Parking Management Plan prepared by CivTech
Dated October 21, 2020

RE: PARKING MANAGEMENT PLAN FOR THE SMOKE TREE RESORT PROJECT – PARADISE VALLEY, ARIZONA

Subject: Parking Management Plan for Smoke Tree Resort – Paradise Valley, AZ

RE: Response to Comments Provided by Kimley Horn on July 13, 2020 and Question Raised at Planning Commission on July 21, 2020

FIGURE 2 – VALET PLAN

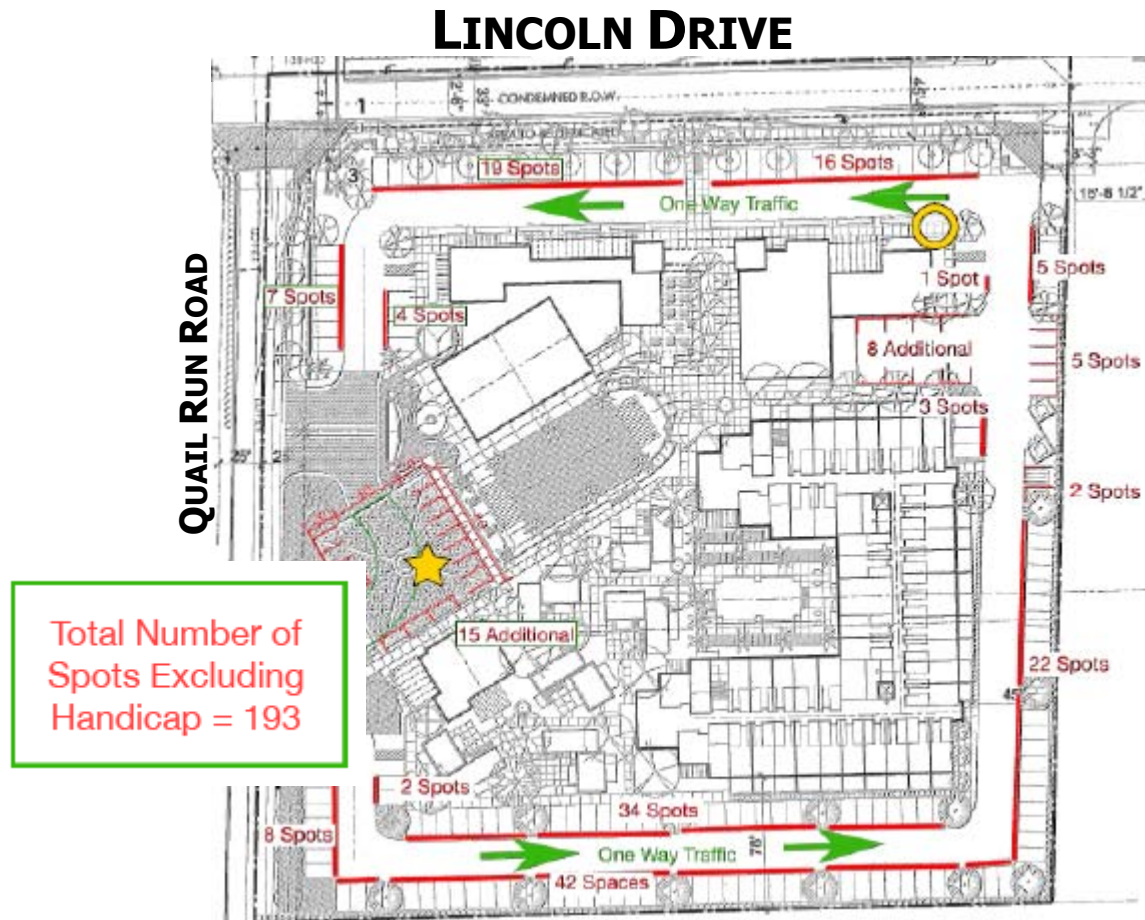
2. On Page 5: Update Table 3 to contain a column with the land use densities being modeled.
3. Page 9: Figure 2 – Valet Plan: Based on this figure it is unclear where the pick-up and drop-off locations will be provided. The designated pick-up/drop-off area appears to be under the Resort Reception Entry Plaza and Valet; however, the layout of this area is unclear. When the traffic flow is converted to one-way traffic, the area under the Resort Reception Entry Plaza and Valet will be required to provide sufficient space for the pick-up and drop-off of vehicles. Using a one-way traffic flow, vehicles will be returned from the North of the parking lot but will not have an area to turn around at the pick-up/drop-off location. Please provide responses to the following:

Item	Review Comment	(Code) & Response
3.	<p>2 – Valet Plan: Based on this figure it is unclear where the pick-up and drop-off locations will be provided. The designated pick-up/drop-off area appears to be under the Resort Reception Entry Plaza and Valet; however, the layout of this area is unclear. When the traffic flow is converted to one-way traffic, the area under the Resort Reception Entry Plaza and Valet will be required to provide sufficient space for the pick-up and drop-off of vehicles. Using a one-way traffic flow, vehicles will be returned from the North of the parking lot but will not have an area to turn around at the pick-up/drop-off location. Please provide responses to the following:</p> <ul style="list-style-type: none"> • Will drivers be expected to circle around the parking lot to exit? • Will a roundabout be provided at the pick-up/drop-off area? • Has a queuing analysis been performed to determine the number of vehicles that can be serviced in this pickup/drop-off area before spilling over into Quail Run Rd.? • Has a turning radius analysis been conducted to ensure that vehicles will have enough turning space and avoid other vehicles? 	<p>Further information regarding the secondary exit only Quail Run driveway and other detailing valet information has been attached to these comments.</p> <ul style="list-style-type: none"> • Will drivers be expected to circle around the parking lot to exit? Drivers will not be expected to drive around the resort. There will be the main entry on Quail Run and a secondary exit only access that connects to Quail Run on the south side of the entry plaza for guests to leave. • Will a roundabout be provided at the pick-up/drop-off area? <i>A round about will not be provided at the pick-up/drop-off area, although, a secondary access will be provided for direct access to Quail Run Road to exit, and to avoid the need to circulate around the site.</i> • Has a queuing analysis been performed to determine the number of vehicles that can be serviced in this pickup/drop-off area before spilling over into Quail Run Rd.? <i>Valet has not done a queuing analysis, although there are alternative scenarios that could occur to prevent queuing offsite such as staffing heavier and providing a second valet stand on the north side of the property towards the shared driveway with Lincoln Medical Center with signage pointing the intended entry to events. Approximately 162 feet is provided from the entry on Quail Run Road to the valet stand which could accommodate up to 8 vehicles simultaneously. The Smoke Tree site is smaller in scale and the number of attendants working the valet stand can be increased to control the queue. Should the queue be anticipated to exceed the 8 vehicles stacking distance, the second valet stand along the northern edge of the site should be implemented. This is discussed in the PMP.</i> • Has a turning radius analysis been conducted to ensure that vehicles will have enough turning space and avoid other vehicles? <i>With a secondary exit access onto Quail Run a turn around movement would not need to be made. An autoturn analysis for the site indicated that all deliveries, including small truck deliveries should be made to the delivery area on the east side of the site. This has been added to the PMP.</i>

The Resort Reception Entry Plaza does not have any structure above vehicles providing sufficient clearance for any vehicle. Additionally, the secondary Quail Run Road exit-only driveway will provide sufficient area for a delivery vehicle to exit without using the turnaround. Passenger vehicle and delivery vans are both accommodated by the size of the delivery area. An autoturn analysis indicated that small delivery trucks such as SU-30 and SU-40 vehicles would be required to stop at the delivery area provided on the east side of the site.

PROPOSED SITE PLAN - GROUND LEVEL

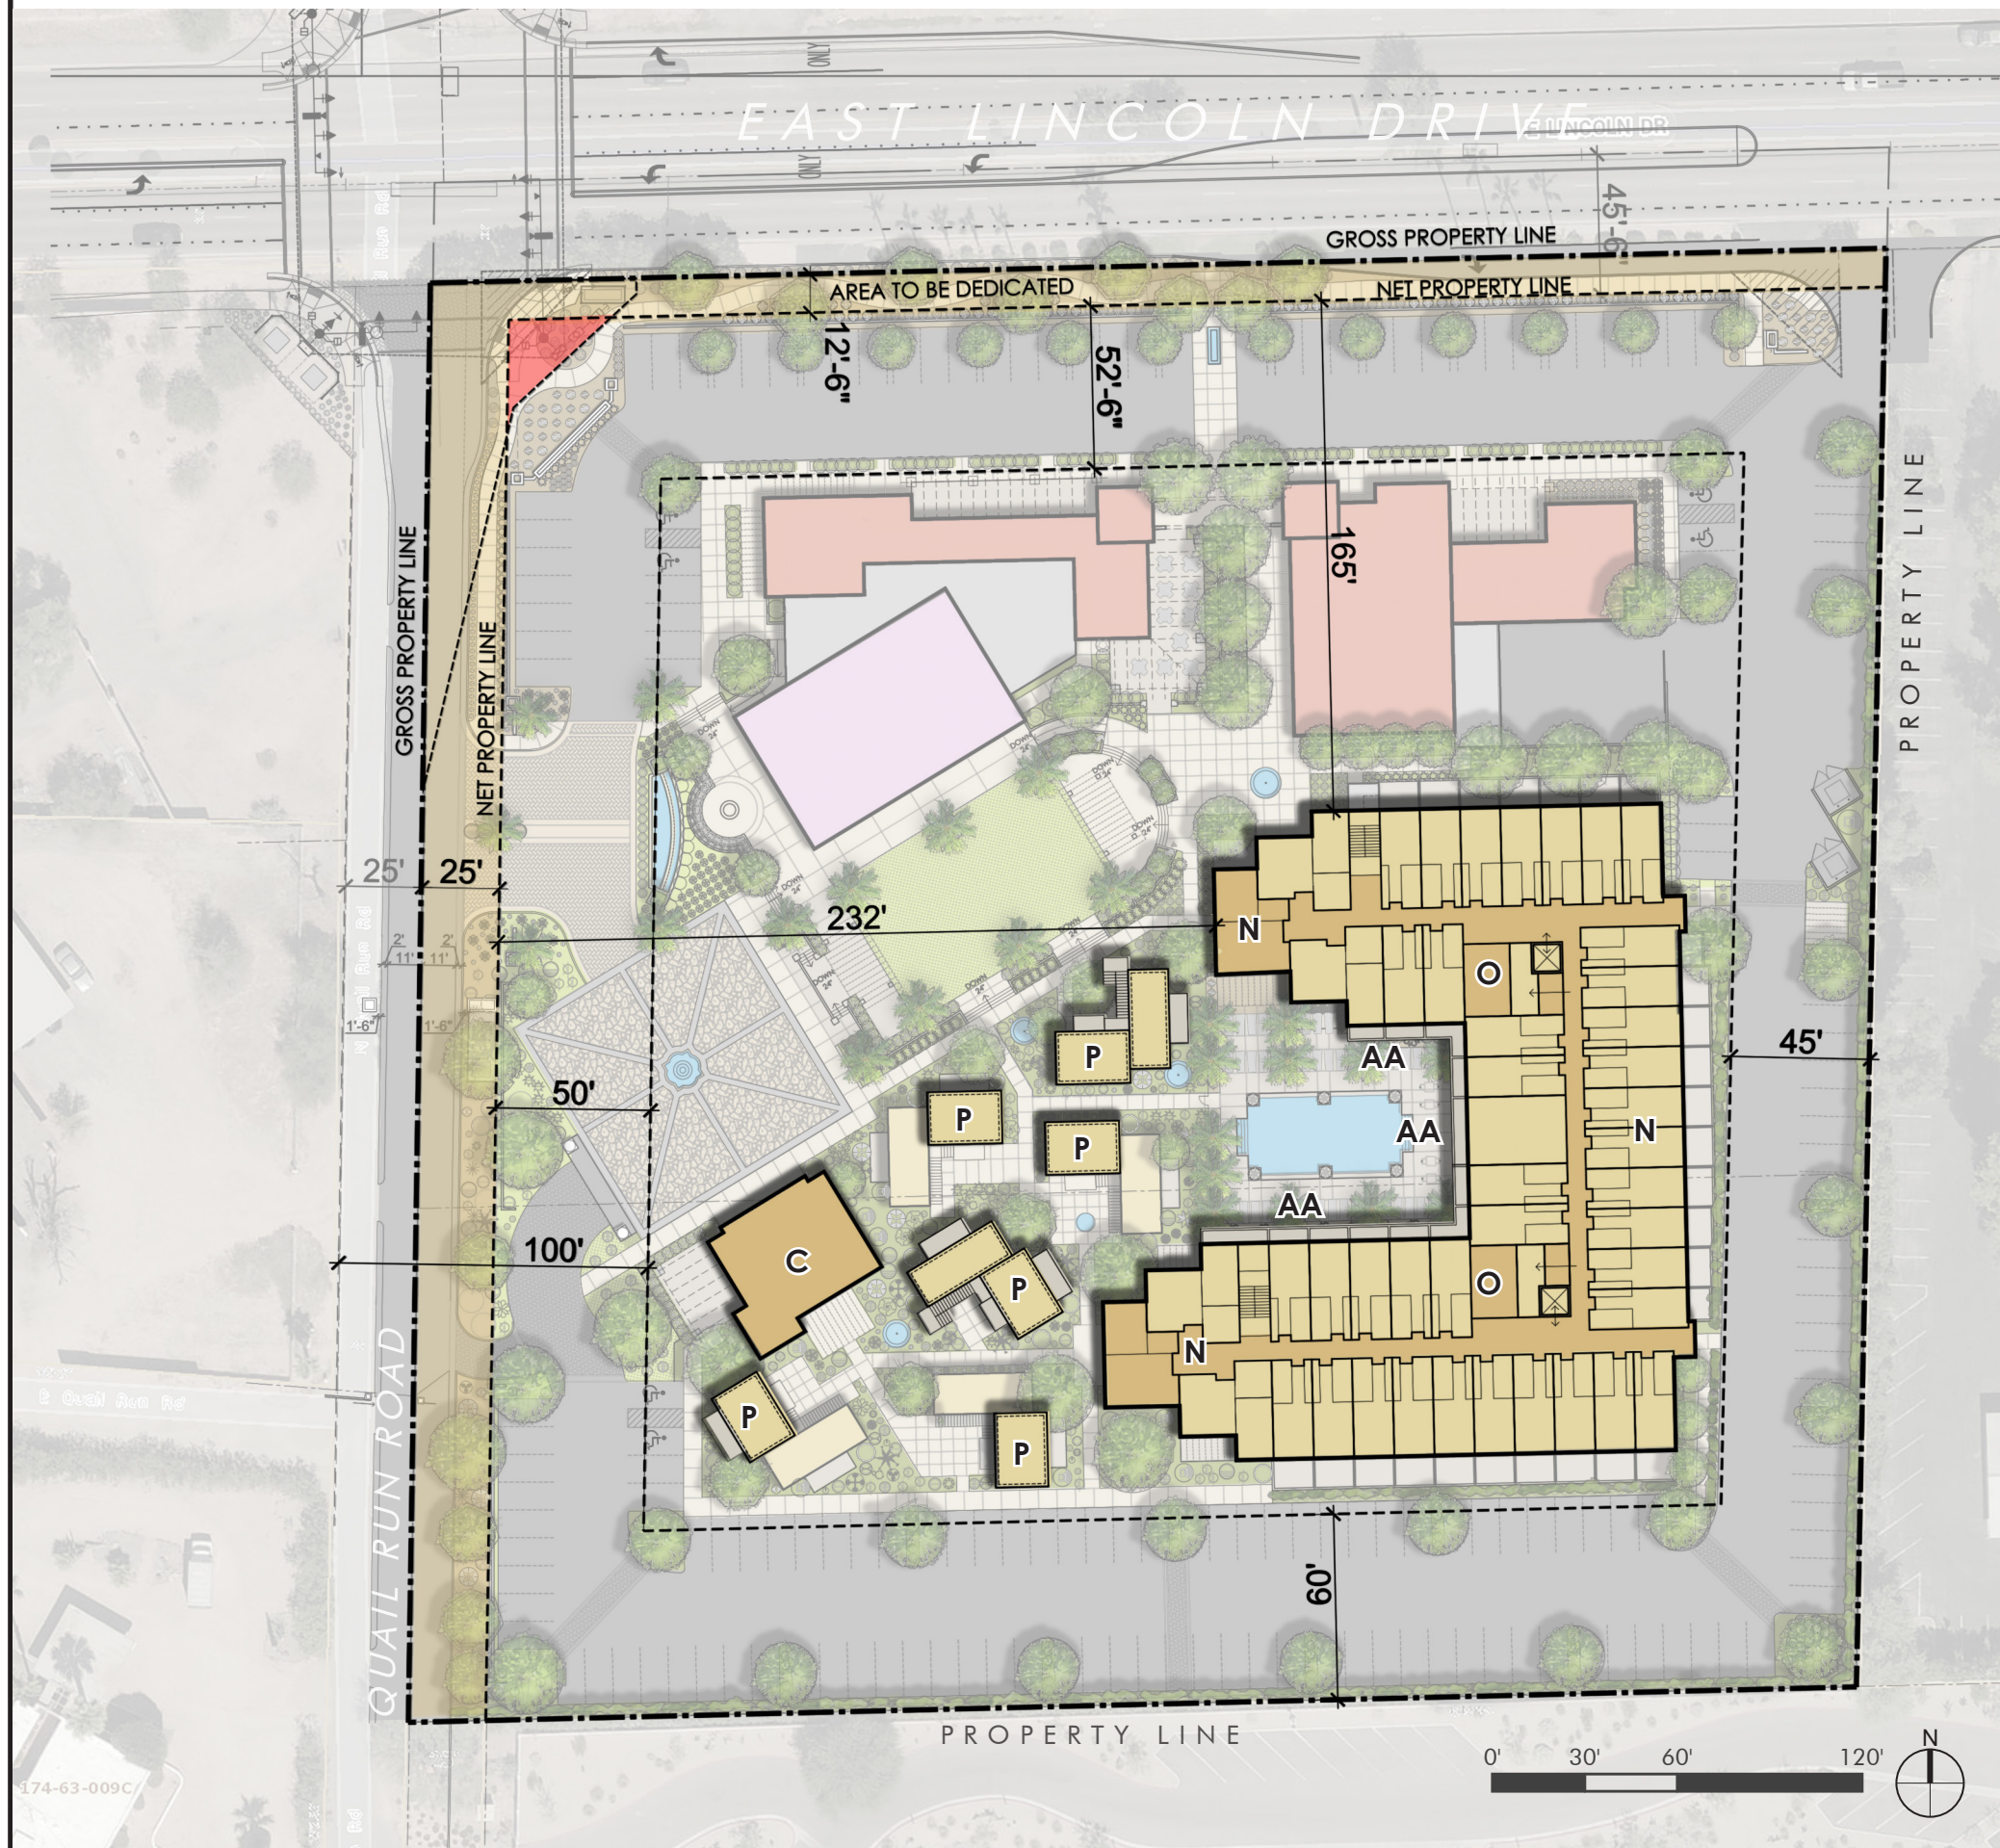
4.	Appendix A, Site Plan - Show proposed secondary access point on Quail Run Rd.	(1) Acknowledged, the site plan with the exit only drive on Quail Run Road has been added.

VALET PLAN

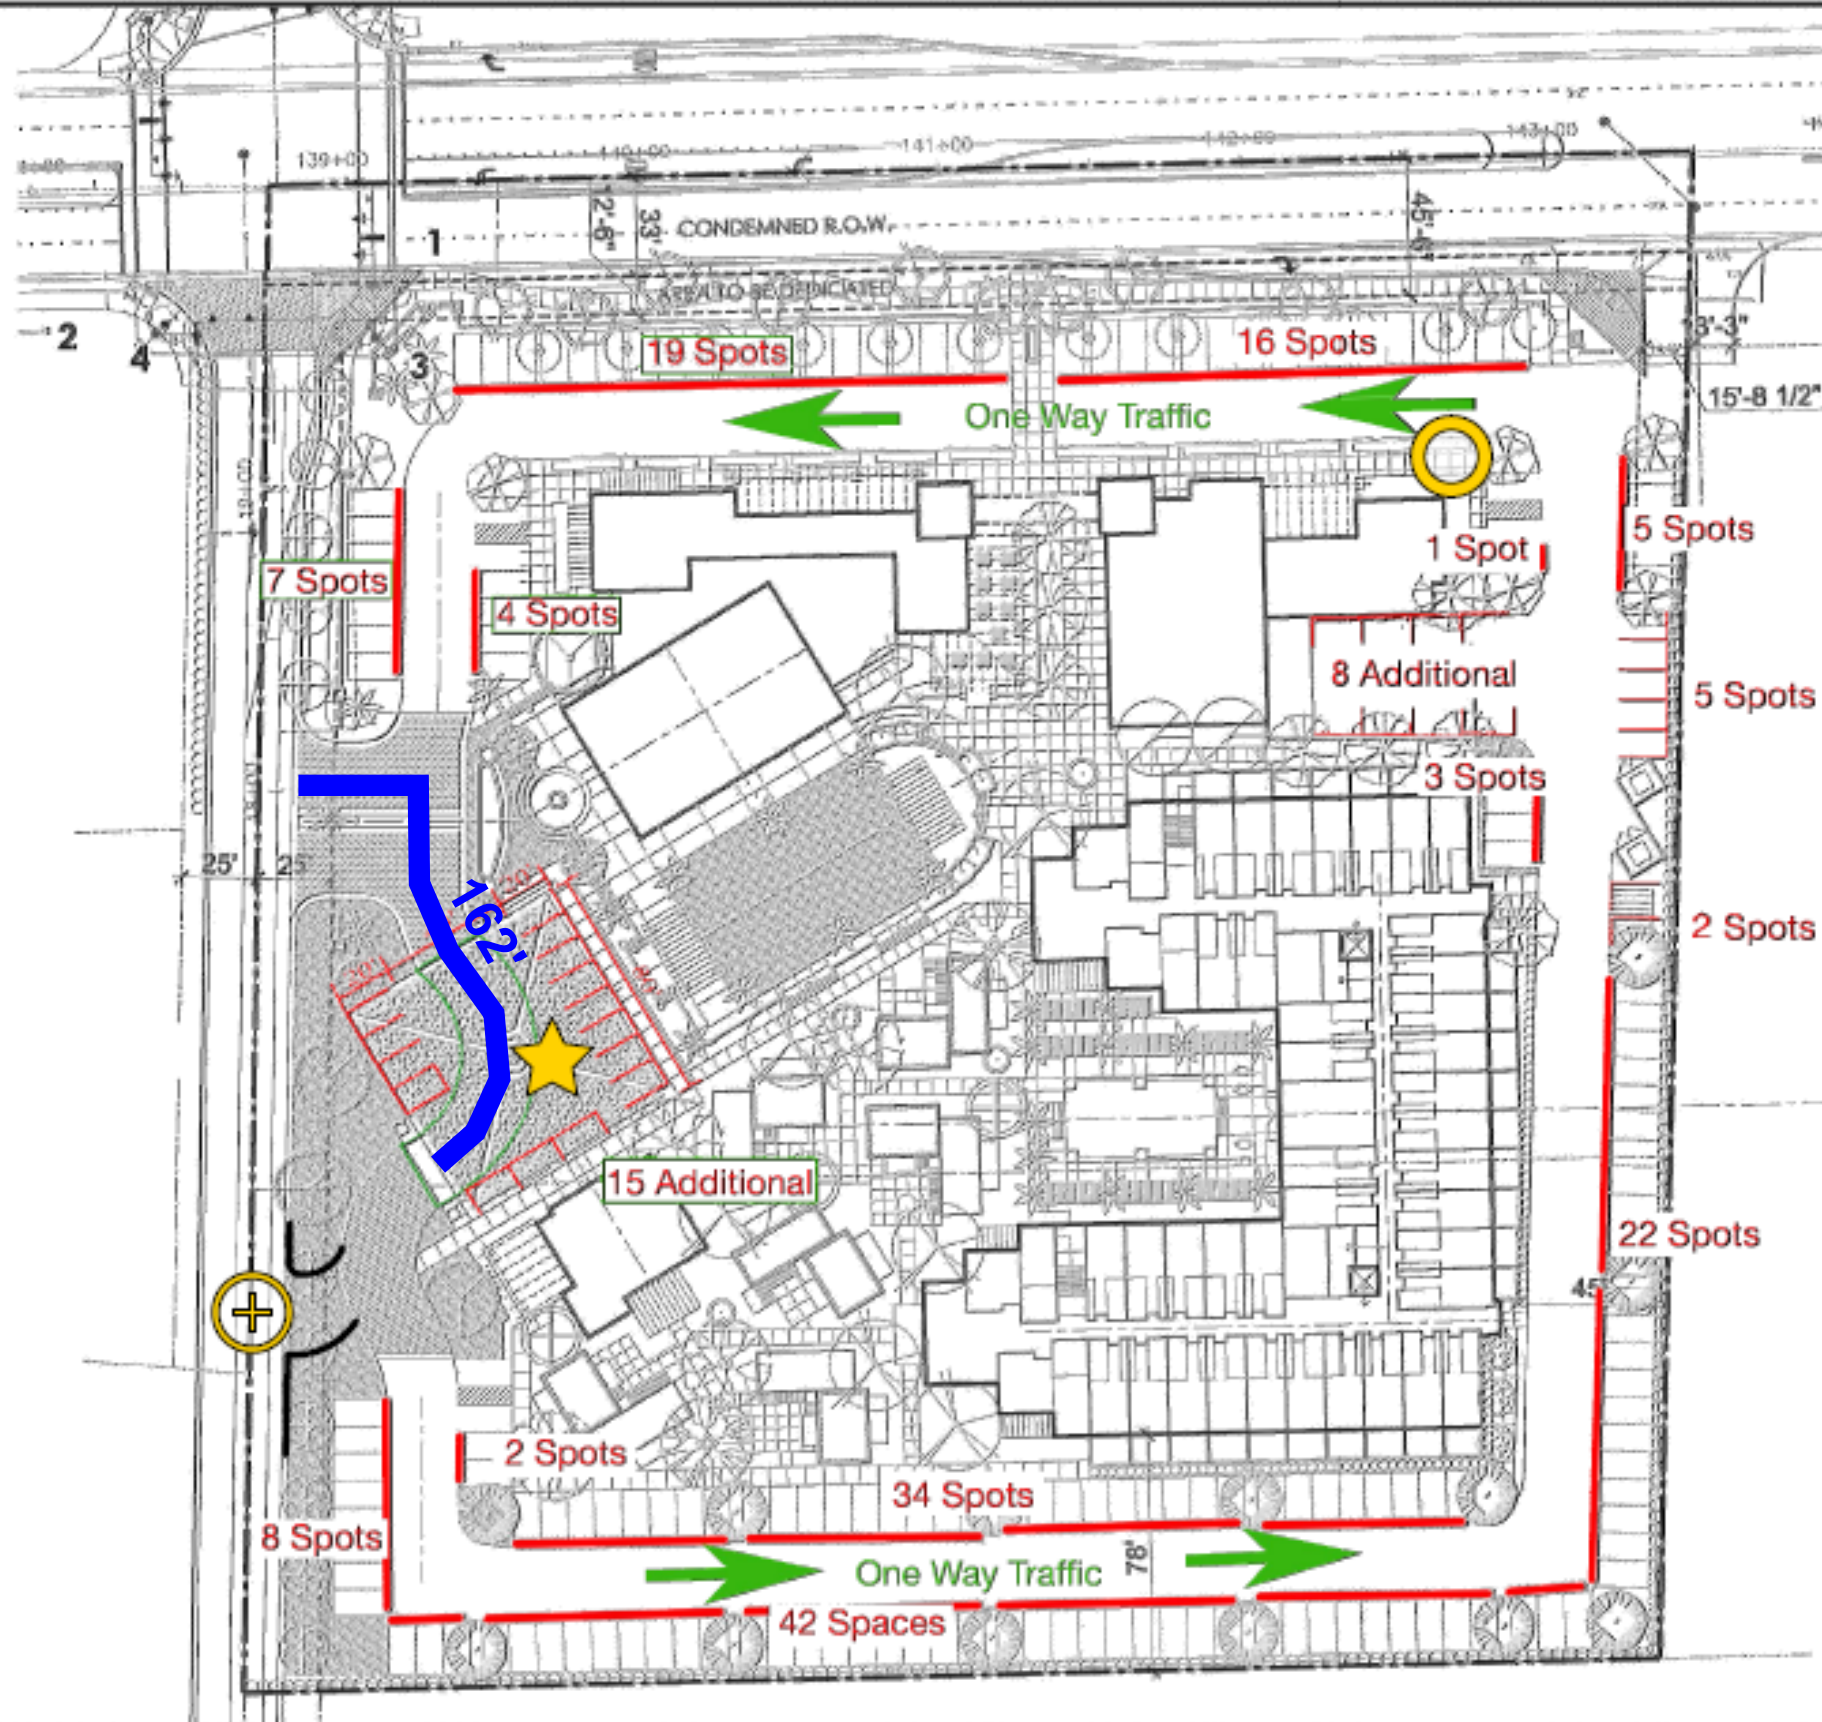
5.	Appendix B, Valet Plan - Show 162' Dimension from main valet stand to Quail Run Rd. for vehicle queue	(1) Acknowledged, the approximate distance has been drawn into the valet plan for visual clarity.
